CRYSTAL RIVER UNIT 3 NUCLEAR GENERATING PLANT

AMENDMENT TO FACILITY OPERATING LICENSE

Amendment No. 13
License No. DPR-72

ATTACHMENT TO LICENSE AMENDMENT NO. 13

Figure 6.2-1 Offsite Organization

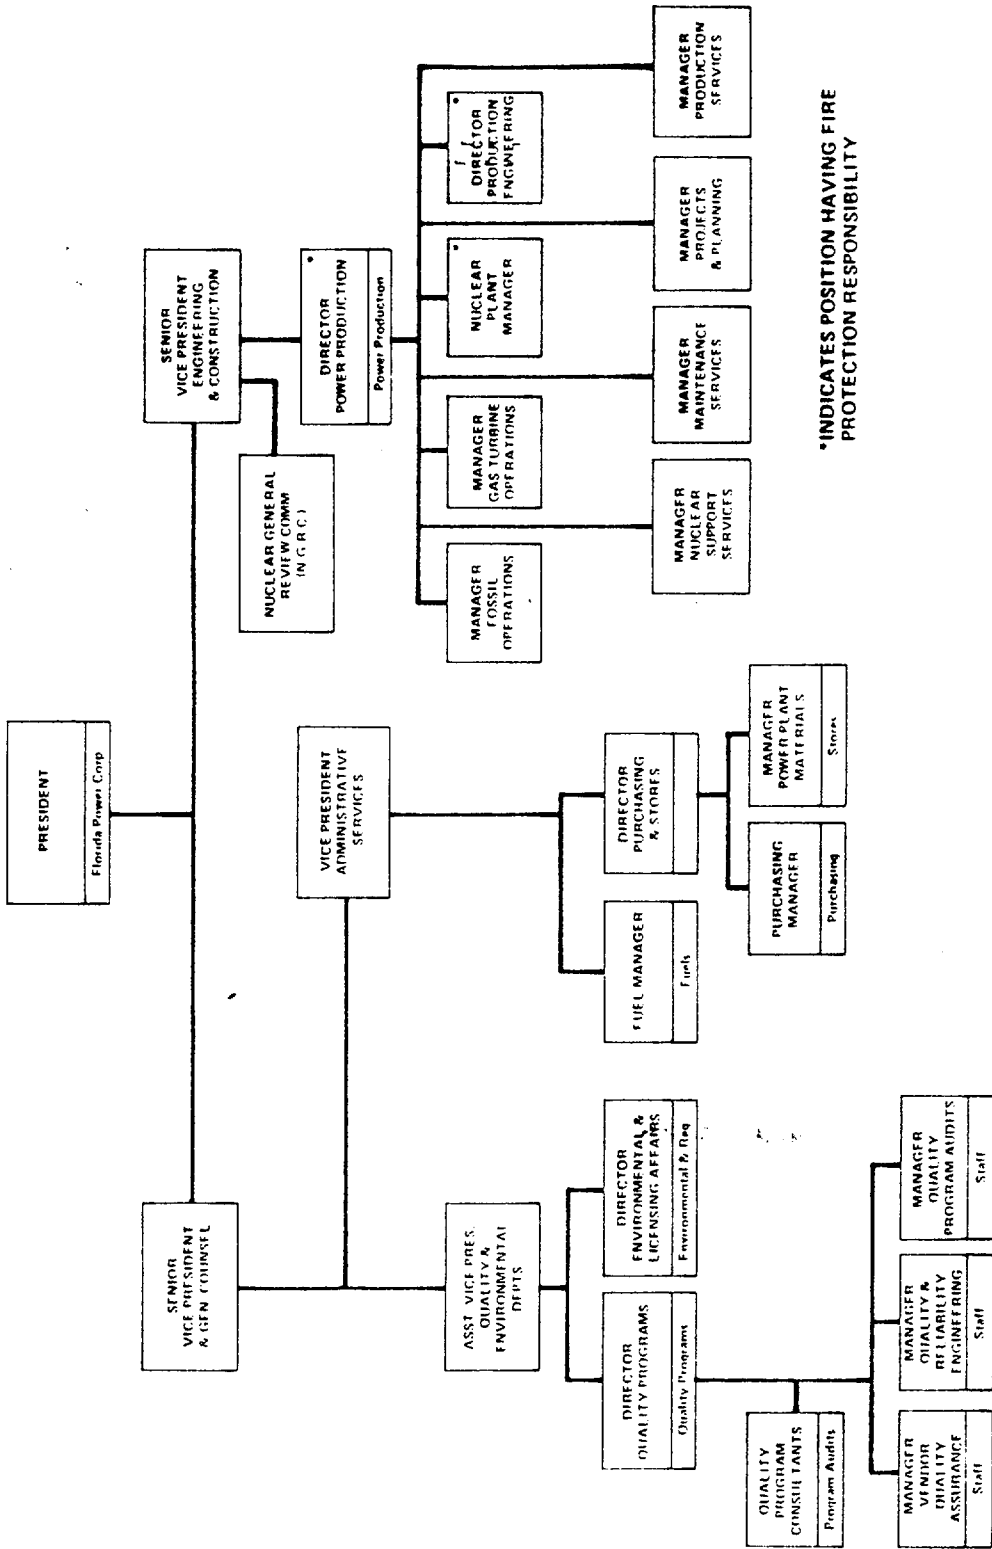
6.2.1 The offsite organization for facility management and technical support shall be as shown on Figure 6.2-1.

Figure 6.2-2 Facility Organization

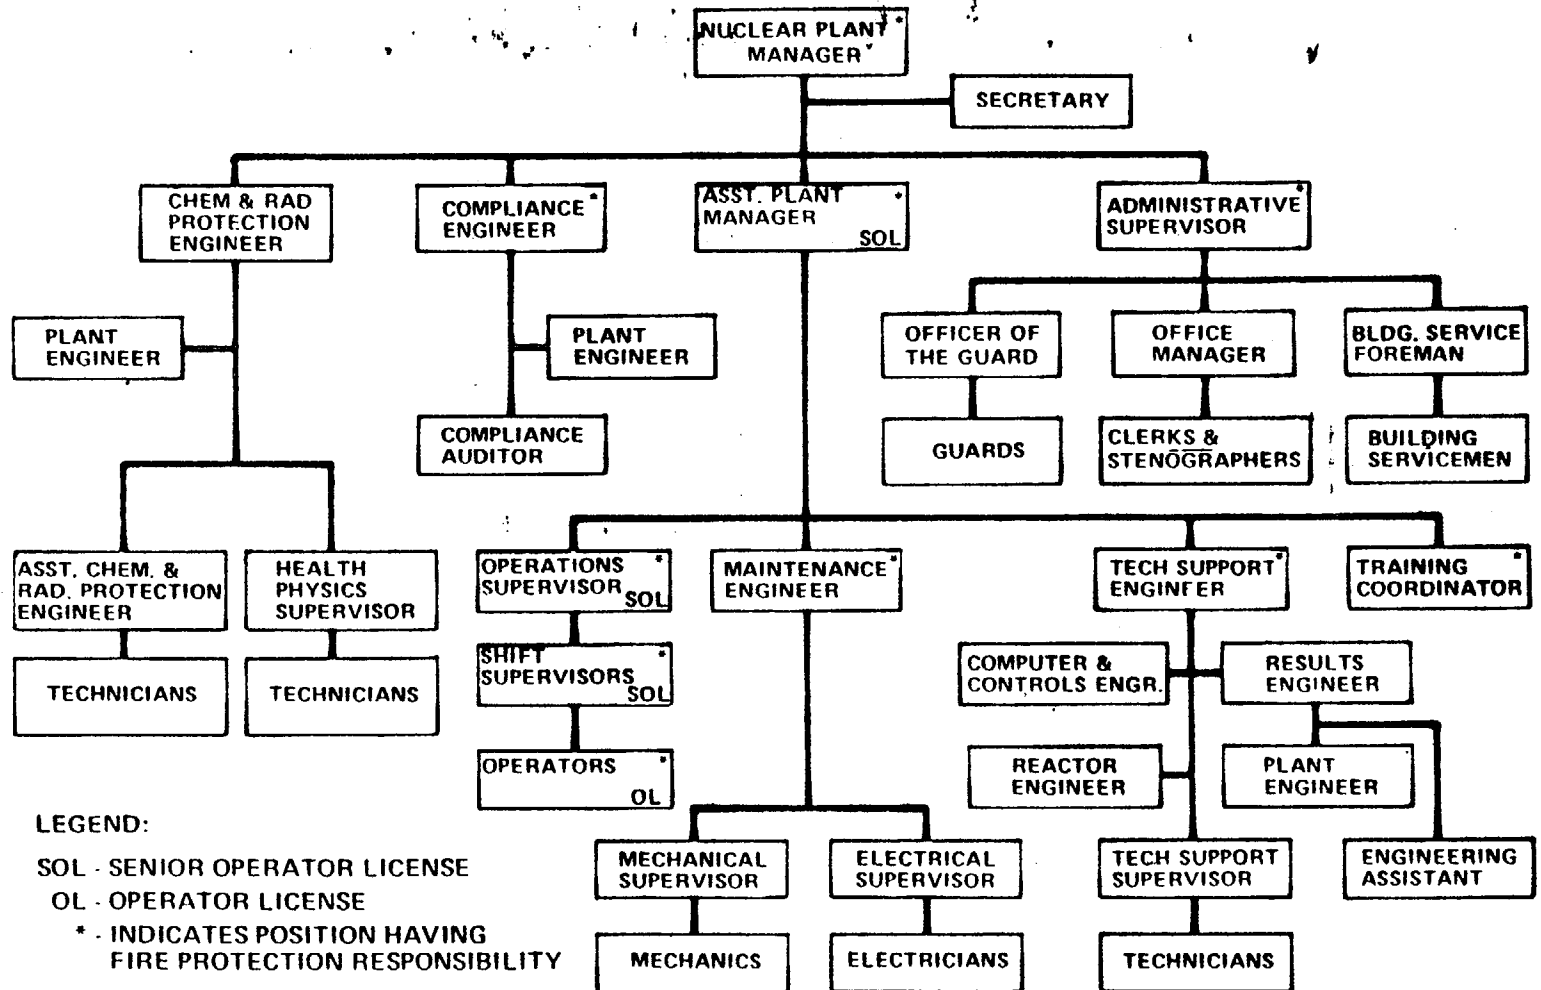
6.2.2 The Facility organization shall be as shown on Figure 6.2-2 and:

- f. A Fire Brigade of at least 4 member shall be maintained onsite at all times. This excludes 5 members of the minimum shift crew necessary for safe shutdown of the plant and personnel required for other essential functions.
